STERLING HILLS FILING NO. 15 PRELIMINARY PLAT

A RESUBDIVISION OF LOT 1, BLOCK 1, STERLING HILLS SUBDIVISION FILING NO. 14 SITUATED IN THE SOUTHWEST ONE-QUARTER OF SECTION 27, TOWNSHIP 4 SOUTH, RANGE 66 WEST OF THE SIXTH PRINCIPAL MERIDIAN, CITY OF AURORA, COUNTY OF ARAPAHOE, STATE OF COLORADO

STERLING HILLS FILING NO.15 PRELIMINARY PLAT

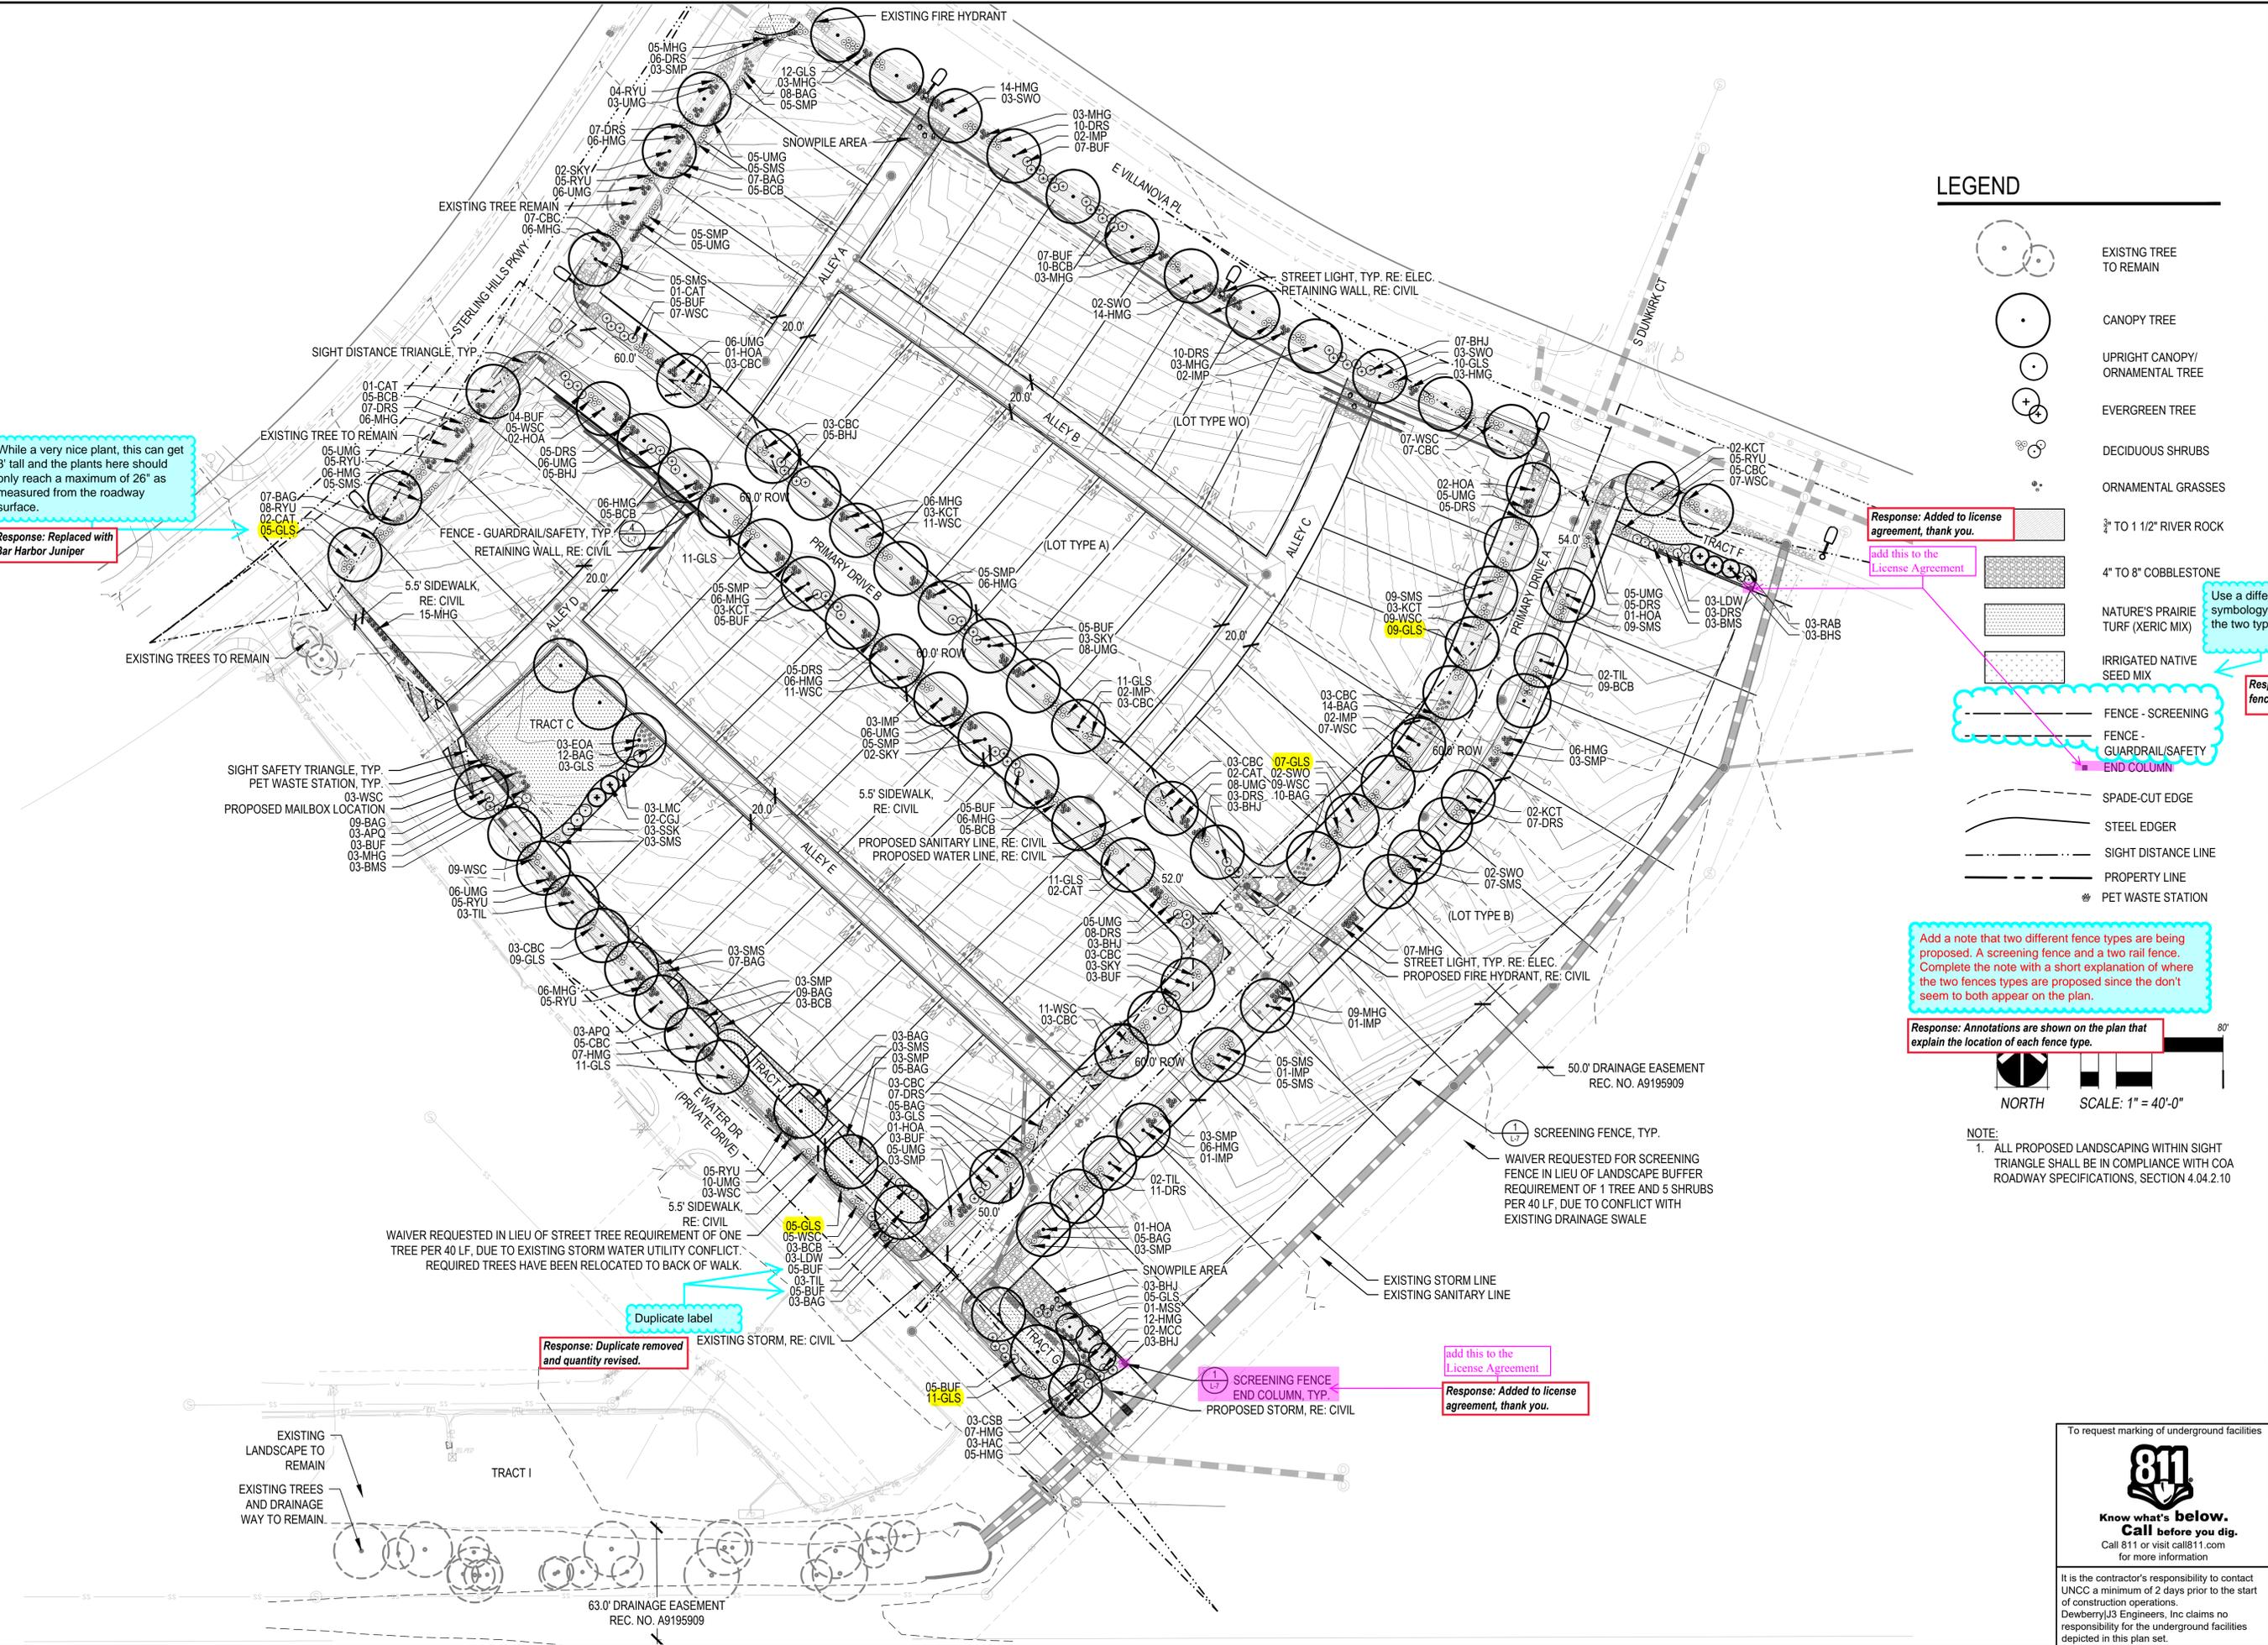
add this to the License Agreement

Use a different fence symbology to separate the two types.

Add a note that two different fence types are being proposed. A screening fence and a two rail fence. Complete the note with a short explanation of where the two fences types are proposed since the don't seem to both appear on the plan.

While a very nice plant, this can get 3' tall and the plants here should only reach a maximum of 26" as measured from the roadway surface.

Duplicate label

add this to the License Agreement

These need to be broken down by each side of the street not as one street. The requirement should be met individually for each side of the street. It appears that it likely is being met, but must be listed individually. **Response: Shrub equivalents broken out per side of street**

Response: Added to license agreement, thank you.

Response: Revised so that fence types are differentiated.

Response: Annotations are shown on the plan that explain the location of each fence type.

Response: Replaced with Bar Harbor Juniper

Response: Duplicate removed and quantity revised.

Response: Added to license agreement, thank you.

ON-LOT TYPICAL - LOT TYPE WO

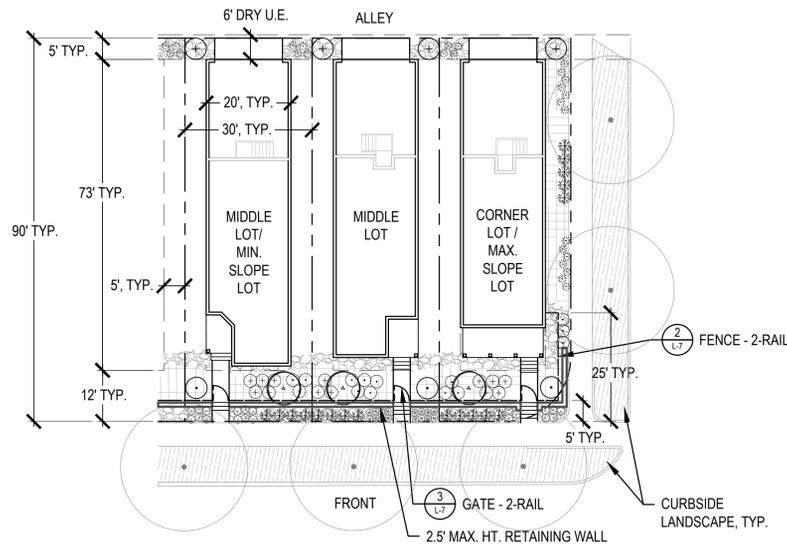
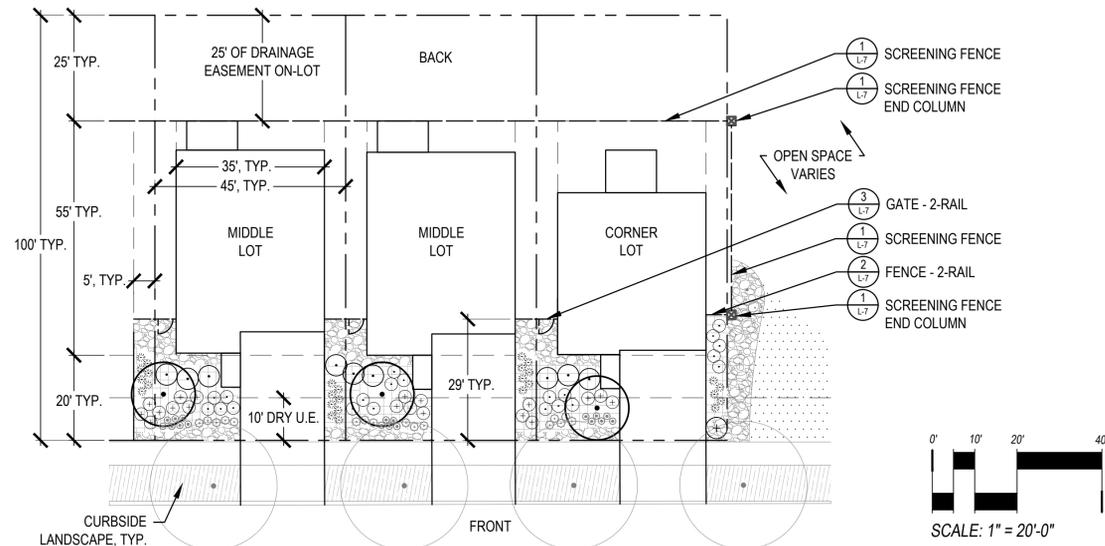
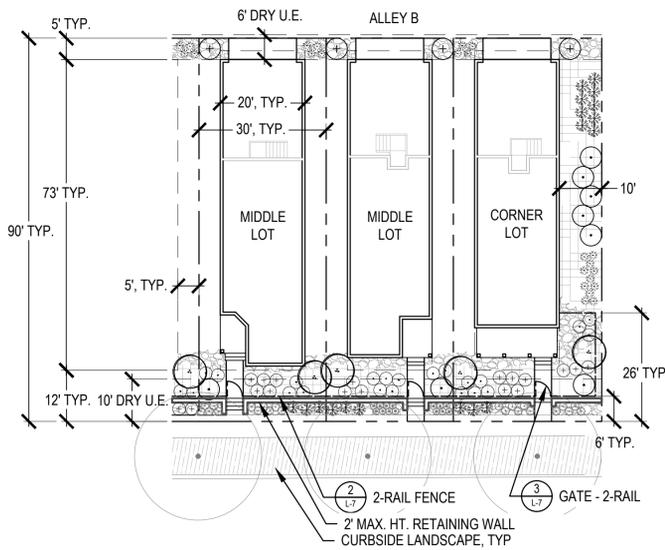
Add the LOT WO standards to the right

Provide a plan on this sheet scaled back without all the plants that delineates the three lot types. These plans are used for inspection purposes. Use three different hatch types.

For those lots that do not have a feature such as the following, these requirements should be updated to include one of the following: a low wall, earth berm or natural boulder.

Because this development is technically not permitted by the GDP/Code and the fact that reduced setbacks are being requested, these lots should have good architecture and front yards that meet code requirements. Include the list of features as noted above and/or one feature for these lot types.

This is misleading. The plan shows only 8 or 9 actual shrubs. If grasses and perennials are to count, then a note should be added here that three one gallon grasses and shrubs are to account for 1 shrub. Even with that, there are not a total of 15 shrubs.

Response: WO landscape requirements added.

Response: Keymap Added

Response: Note added per correspondence, 3/31/2020

Response: Note added per correspondence, 3/31/2020

Response: Note added per correspondence, 3/31/2020 regarding 3 one-gallon perennials accounting for one shrub equivalent, but not accounting for more than 30% of the requirement total. Graphic quantities represented in plans revised to meet minimum requirements.

A RESUBDIVISION OF LOT 1, BLOCK 1, STERLING HILLS SUBDIVISION FILING NO. 14
 SITUATED IN THE SOUTHWEST ONE-QUARER OF SECTION 27, TOWNSHIP 4 SOUTH, RANGE 66 WEST
 OF THE SIXTH PRINCIPAL MERIDIAN, CITY OF AURORA, COUNTY OF ARAPAHOE, STATE OF COLORADO
 SHEET 3 OF 7

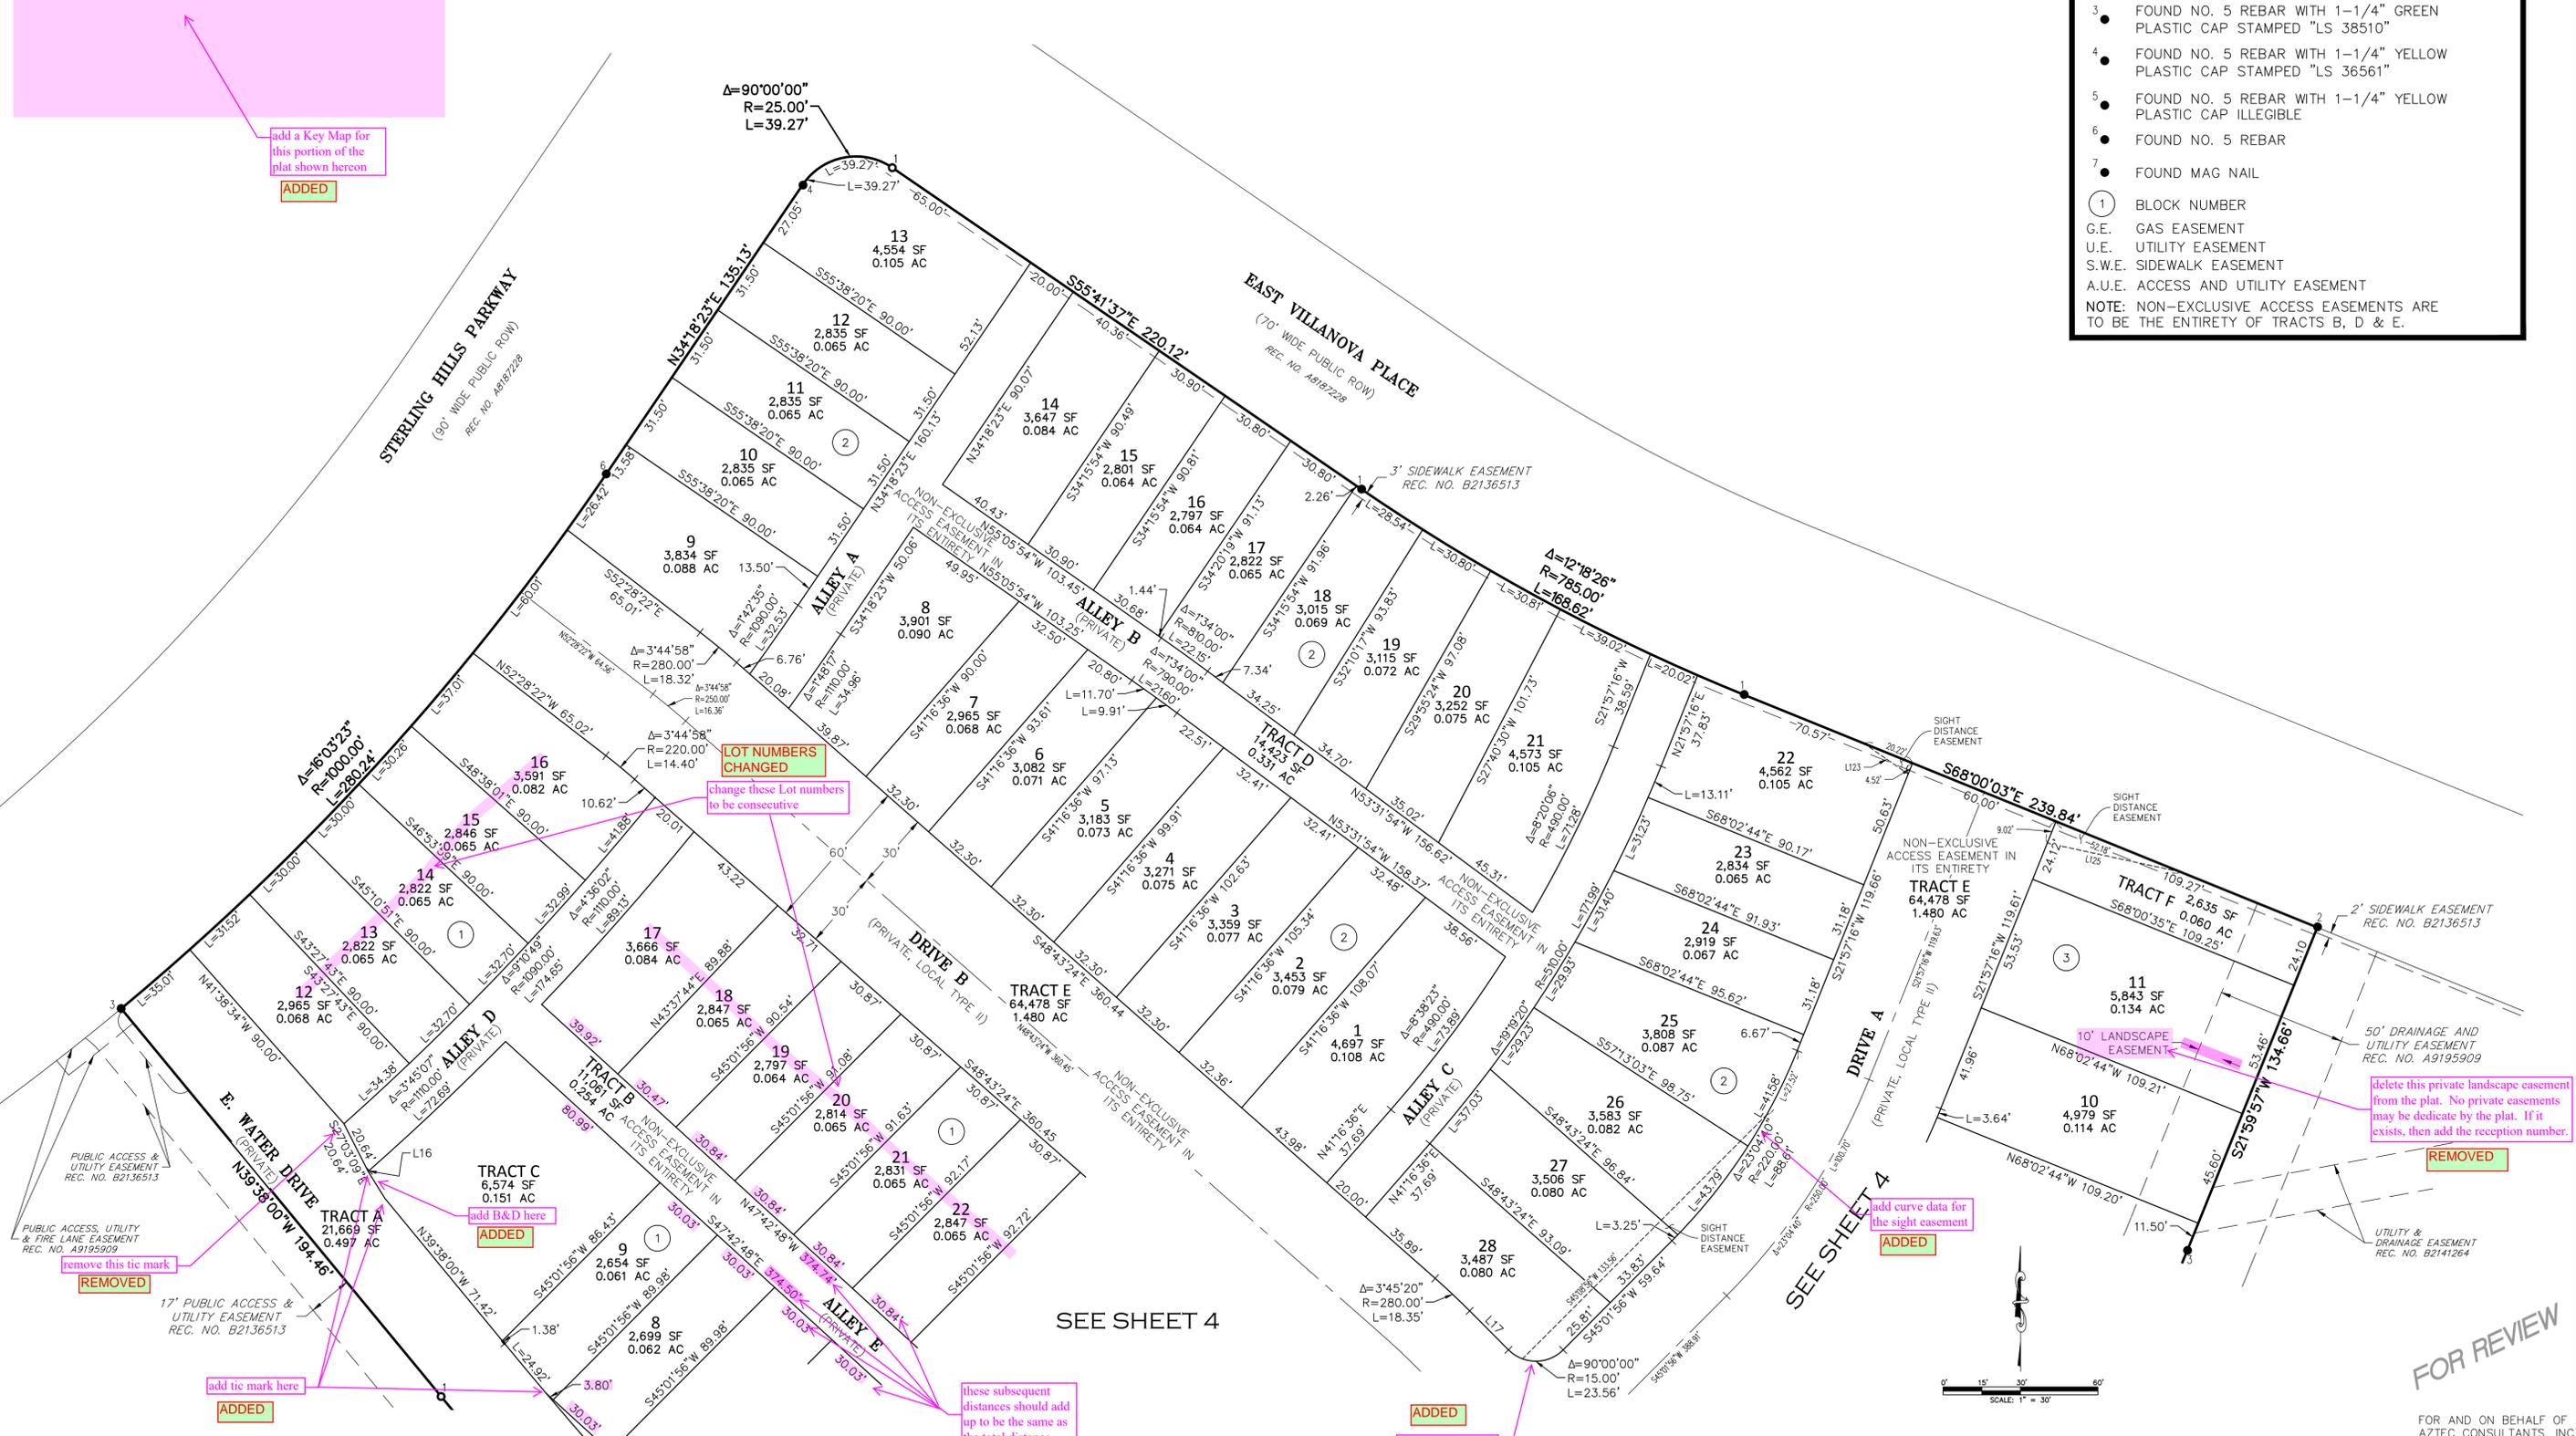
add a Key Map for this portion of the plat shown hereon
ADDED

LOT NUMBERS CHANGED
 change these Lot numbers to be consecutive

remove this tie mark
REMOVED

add B&D here
ADDED

these subsequent distances should add up to be the same as the total distance
DISTANCES CORRECTED

add curve data for the sight easement
ADDED

add curve data for the sight easement
ADDED

delete this private landscape easement from the plat. No private easements may be dedicated by the plat. If it exists, then add the reception number.
REMOVED
